SERVICE BULLETIN

No. 286

Piper Aircraft Corporation

<u>Subject:</u>	Main Landing Gear (Inboard) Door Hinge Attaching Rivets
<u>Models Affected:</u>	PA-31 and PA-31-300 Navajo
<u>Serial Numbers Affected:</u>	31-2 to 31-292 incl.
<u>Compliance Time:</u>	Prior to but not later than the next 50 hours of operation
<u>Purpose:</u>	Provide instructions to replace existing main landing gear (inboard) door hinge attaching rivets (1/8 in. diameter) with larger diameter (5/32 in.) type MS20470AD5-10 (Piper part number 420 236) rivets.
<u>Instructions:</u>	<p>Using standard rivet removal practices, remove existing 1/8 in. diameter rivets that attach the main landing gear (inboard) door hinge (part number 41984-00, fore and aft) to the door hinge attachment angles (part numbers 42048-00, fore and 42048-01, aft). A no. 21 drill is required for drilling the proper size hole for the 5/32 in. diameter rivets.</p> <p>Reassemble door hinges to door hinge attachment angles, using 5/32 in. diameter rivets type MS20470AD5-10, Piper part number 420 236. (See sketch on reverse side of this bulletin.)</p>

MAIN LANDING GEAR INBOARD DOOR

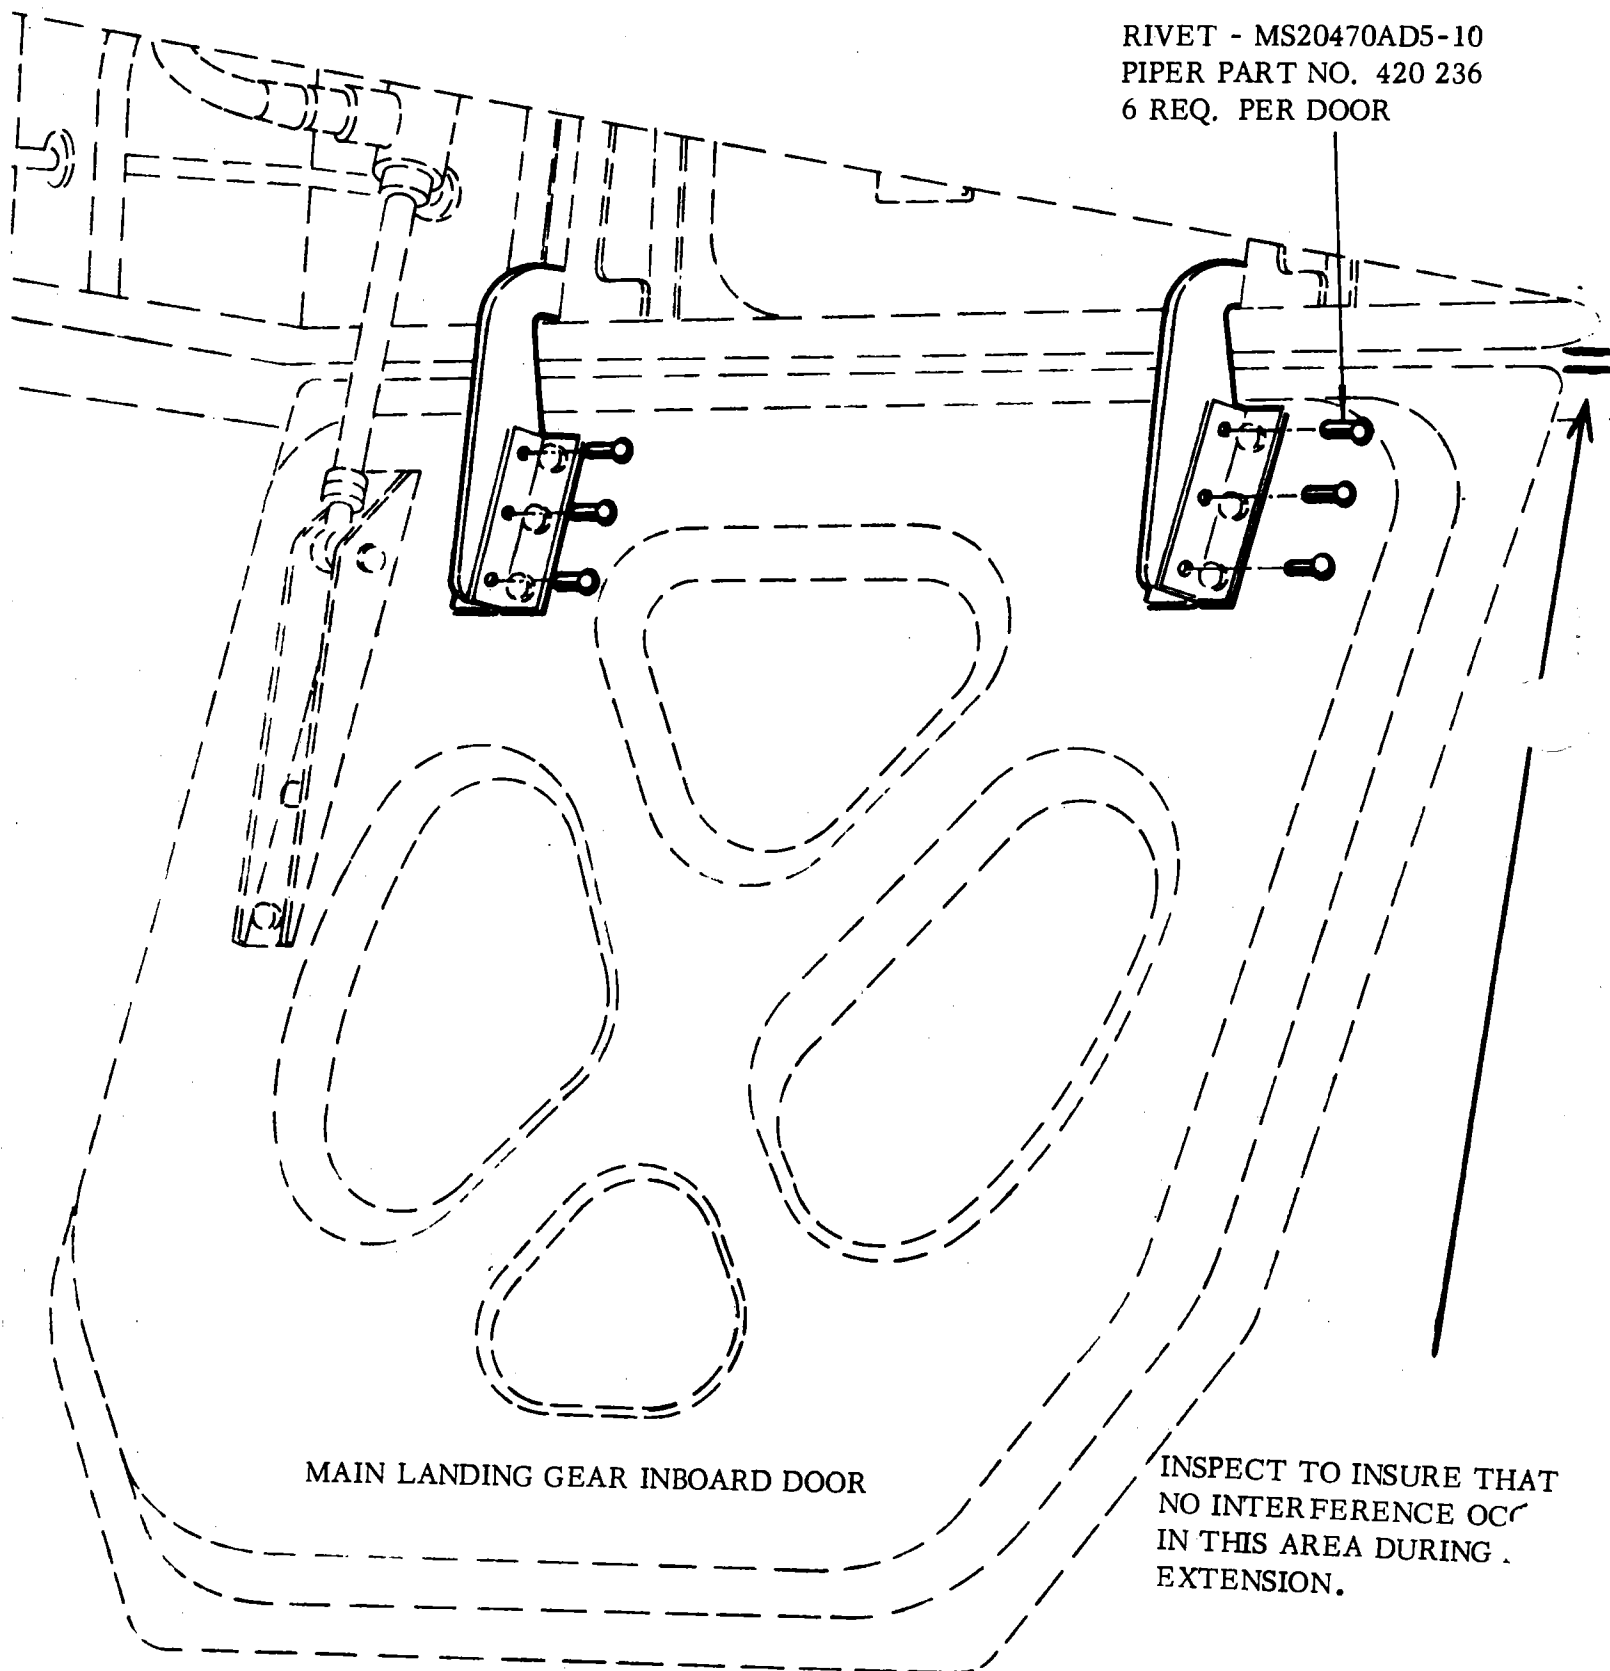
RIVET - MS20470AD5-10
PIPER PART NO. 420 236
6 REQ. PER DOOR

Extend the inboard doors, observing that no interference occurs between the inboard landing gear door skin and the wing skin in the butt rib area.

INSPECT TO INSURE THAT
NO INTERFERENCE OCC
IN THIS AREA DURING
EXTENSION.
